Docket No. 50-275

Twenty-four copies of a report prepared by the Division of Reactor Licensing are transmitted for the review by the Committee. The report is our second report on the proposed Pacific Gas & Electric Company's Diablo Canyon facility. The section on instrumentation is under preparation and will be transmitted as soon as possible.

U. S. ATOMIC ENERGY COMMISSION  
DIVISION OF REACTOR LICENSING  
REPORT TO THE ADVISORY COMMITTEE ON REACTOR SAFEGUARDS  
IN THE MATTER OF  
PACIFIC GAS AND ELECTRIC COMPANY  
DIABLO CANYON NUCLEAR PLANT  
DOCKET NO. 50-275  
REPORT NO. 2

SUMMARY OF HIGH-POWER LEVEL EXPERIMENTS ON FREE STANDING ZIRCALOY CLAD OXIDE FUEL RODS.

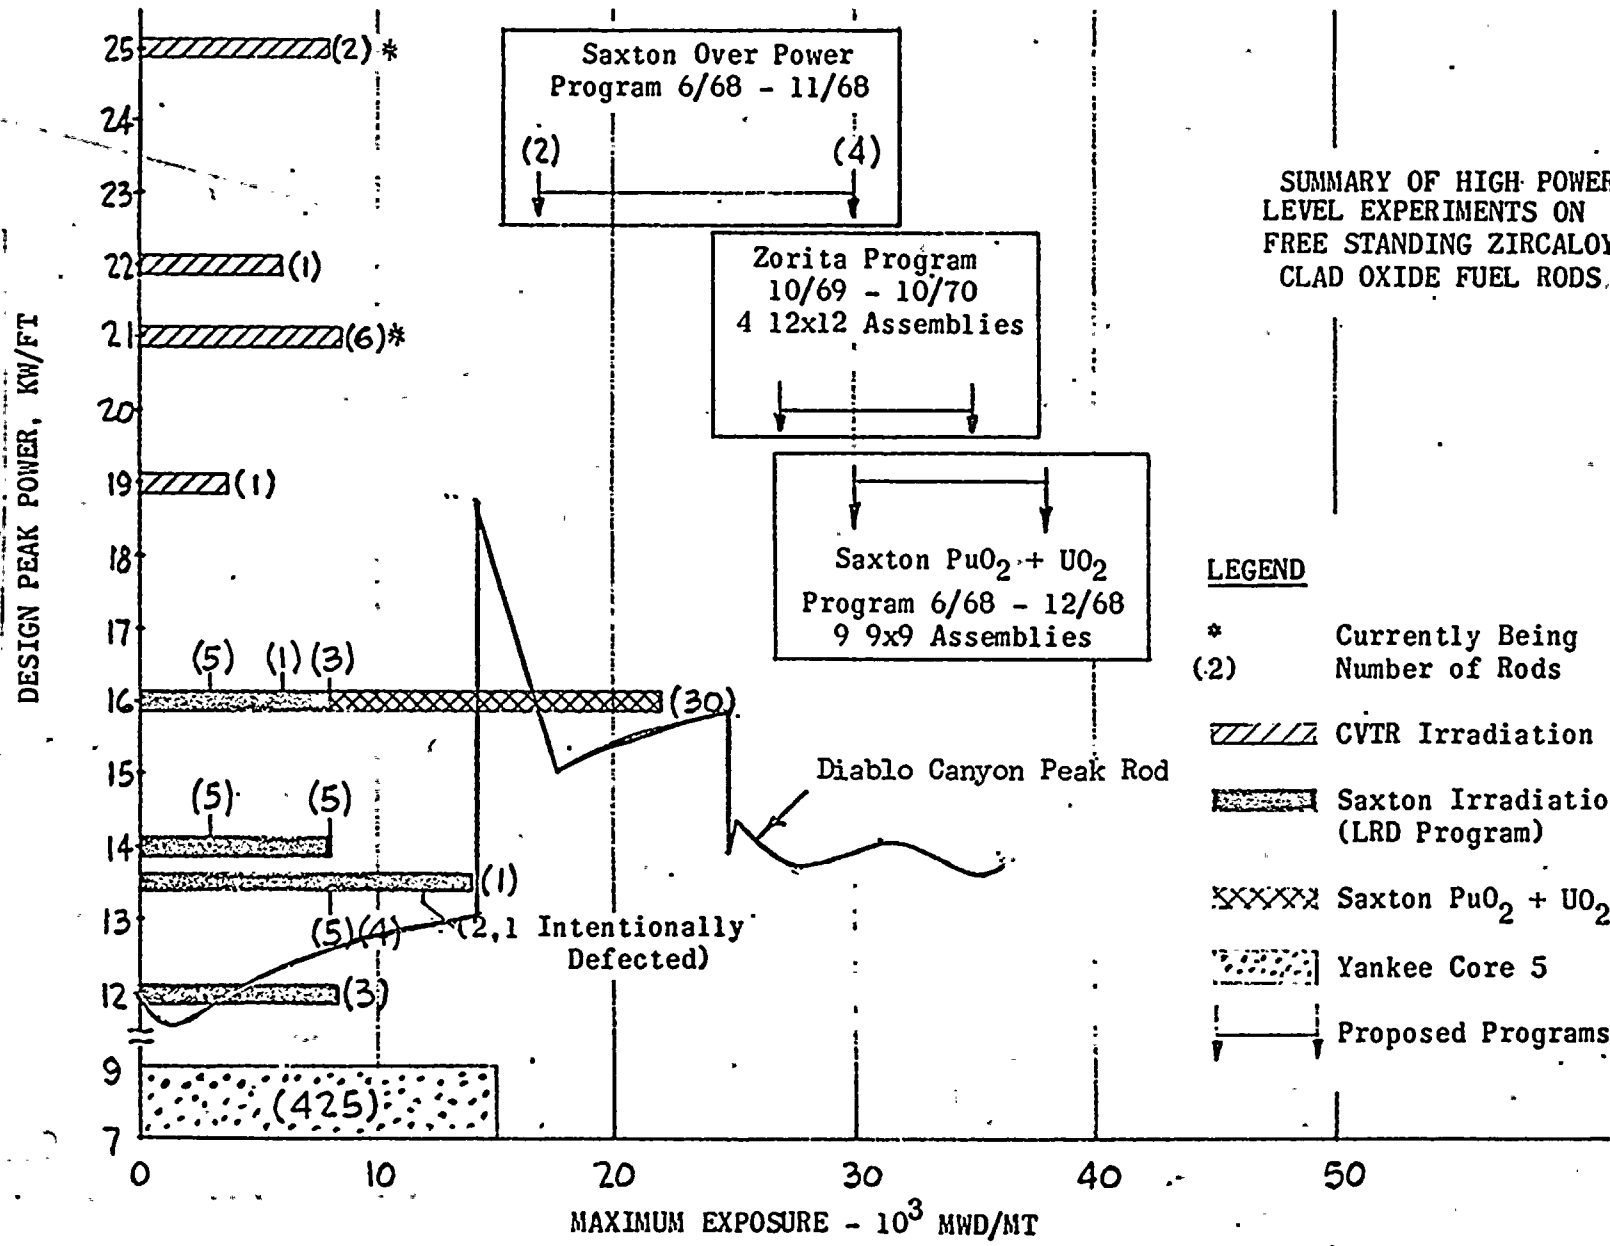
One other aspect of our review for Diablo Canyon is that of fuel performance at proposed peak powers corresponding to expected burnup. The applicant provided a summary bar chart showing both the present and proposed irradiation test programs to demonstrate acceptable fuel performance for this reactor. We have plotted the expected peak rod operating characteristics on this bar chart. As is evident, at the present time there is no satisfactory operating experience at the linear power generation levels contemplated for the Diablo Canyon reactor. We believe, however, the test programs for Saxton and Zorita will provide a basis for predicting operation of the Diablo Canyon facility.
